SUBJECT: INSPECTION REPORT NO. 70-143/2007-207

Report No.: 70-143/2007-207

Licensee: Nuclear Fuel Services, Inc.

### **Nuclear Fuel Services, Inc. NRC Inspection Report No. 70-143/2007-207**

**Figure 1**  
**Glovebox Reflector Arrangement**

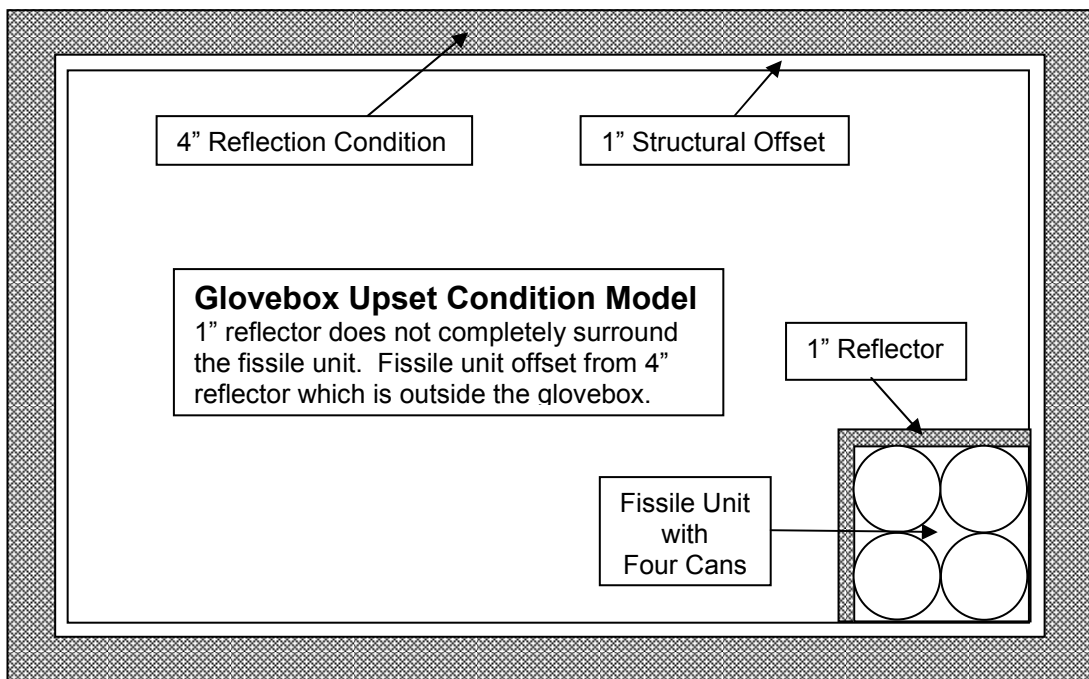
When the licensee relies on computer calculations to demonstrate double contingency, subcritical margin, or performance requirements for accident sequences leading to criticality, the calculations are required to use a 12-inch reflector unless conditions of less than full reflection are maintained. Less than full reflection conditions can be maintained, for example, by placing a barrier around the fissile unit or placing the fissile unit in an enclosure. The requirements for modeling reflection conditions for individual units are discussed in Section 4.2.1.2 of the license application. The minimum reflector condition allowed by the licensee is a 1-inch thick, tight-fitting, layer of water.

The license application specifically spells out when offset of the reflector is allowed. Offset of the reflector in computer calculations is limited to incidental reflection or, in Section 4.2.2.4, to interaction analyses. The inspectors noted that certain licensee calculations associated with gloveboxes contained computer models of fissile units with gaps between the reflector and the fissile unit (see Figure 1). Licensee NCS staff stated that, when a glovebox enclosure was relied on to maintain conditions of less than full reflection, the reflection condition can be modeled on the outside of the enclosure. The inspectors determined that the licensee NCS staff had intermingled requirements for less than full reflection with requirements for incidental reflection.

The inspectors determined that less than full reflection conditions were required to be modeled with a tight fitting layer around the fissile unit. In the glovebox cases, the enclosure is maintaining the conditions around the fissile unit but is not the outer boundary for the fissile unit and should not be used to offset the reflection condition. Therefore, the model shown in Figure 1 would require the one-inch reflector to completely surround the fissile unit if the model was used to demonstrate double contingency, subcritical margin, or performance requirements for an accident sequence leading to criticality.

Licensee NCS staff stated their belief during the inspection that tight fitting reflector conditions were not required for less than full reflection models. The inspectors reviewed a sampling of analyses and noted that, in every case with gaps in a glovebox model, the licensee had complementary models without gaps and that these tight fitting reflector models were situated in the corner of the glovebox so that two of the walls were more than 1-inch thick. Therefore, the inspectors did not identify an example of a

computer model with gaps in the reflector being used to establish compliance. The inspectors noted that the license requirements regarding reflection were complex and would require further review relative to the licensee models. The inspectors also noted that the combination of tight fitting and offset reflectors normally used in licensee models were relatively conservative and no immediate safety concern was identified. The licensee use of gapped reflector models of fissile systems is **Unresolved Item (URI) 70-143/2007-207-01**.
